Amendment Notice 7

Licence Number L8621/2011/1

Licence Holder Roy Hill Iron Ore Pty Ltd

Premises Roy Hill Iron Ore Mine
M46/518 and M46/519
NEWMAN WA 6753

Premises map including waste processing locations, containment infrastructure, emission and monitoring points

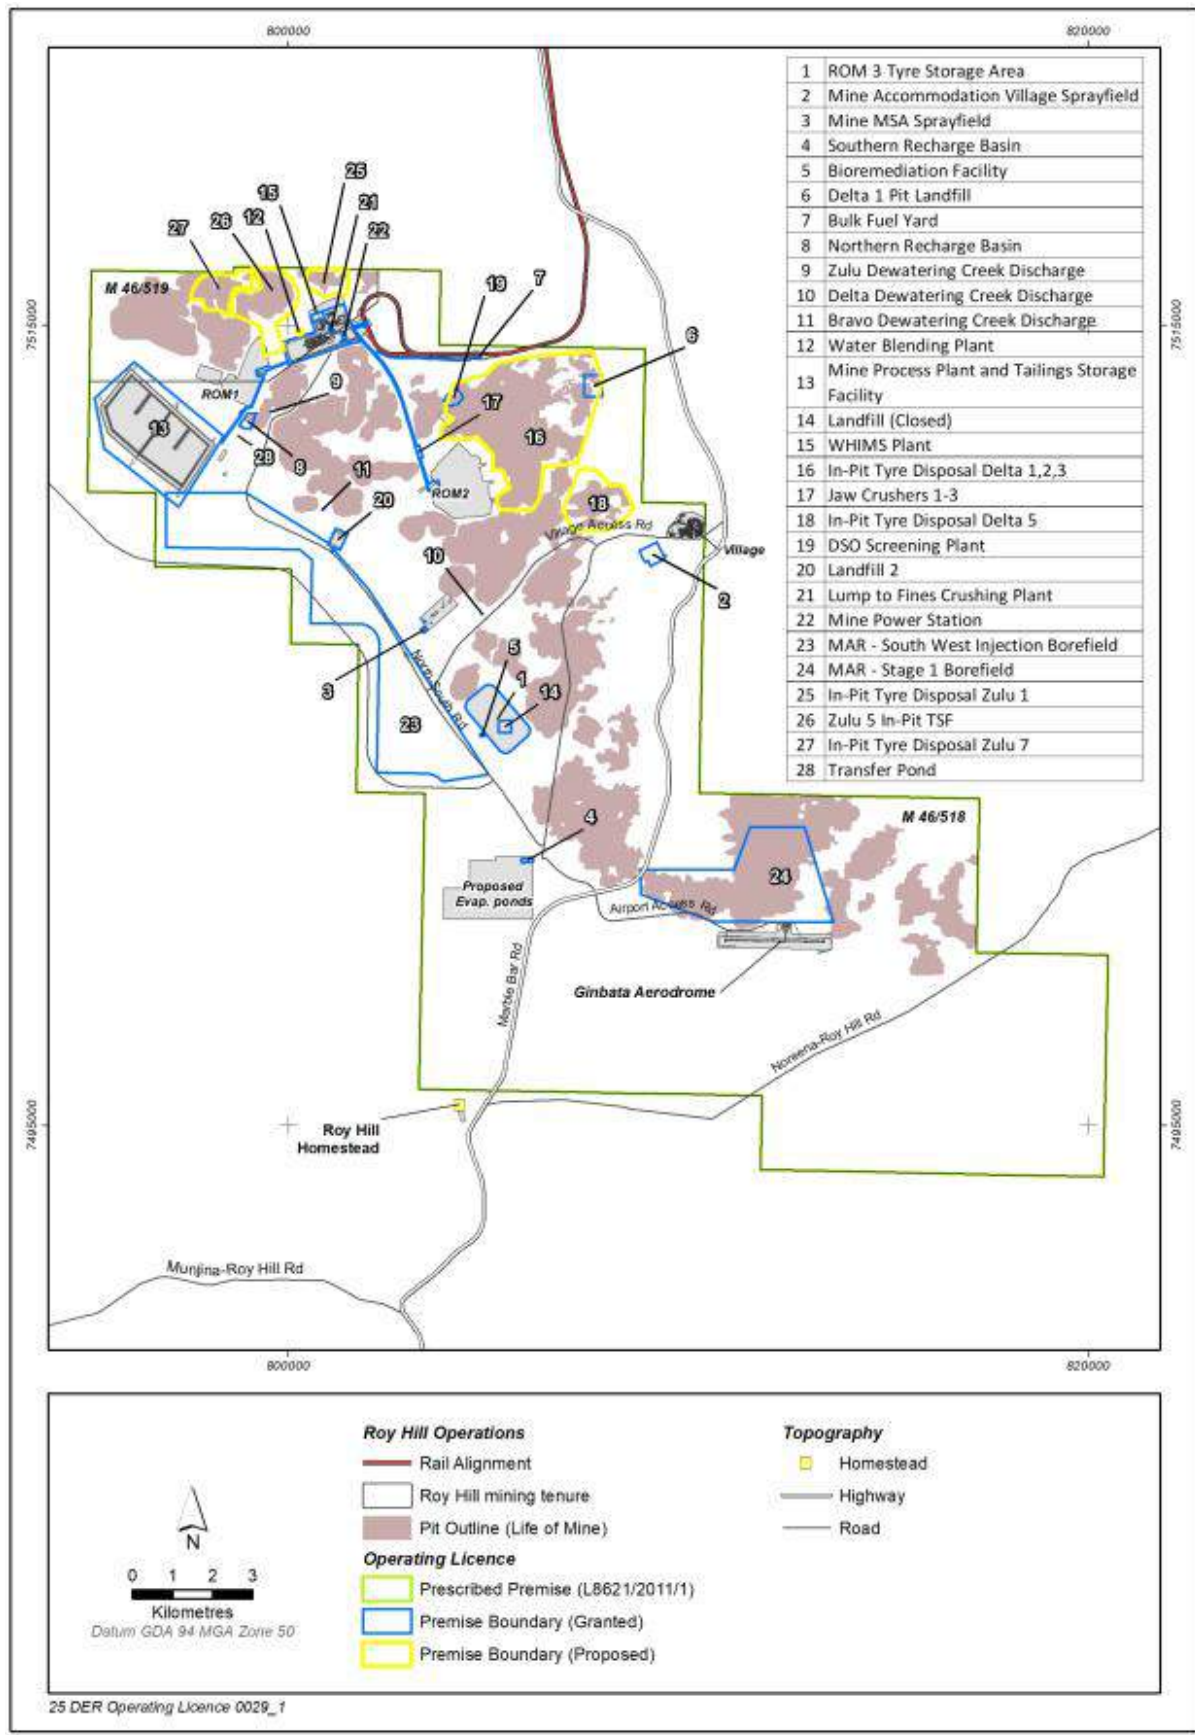
16. Schedule 1: Maps is amended by the removal of the existing Premises Map and insertion of the Premises map below.
17. Schedule 1: Maps is amended by the insertion of the Map of Zulu 5 IPTSF - general arrangement map below.
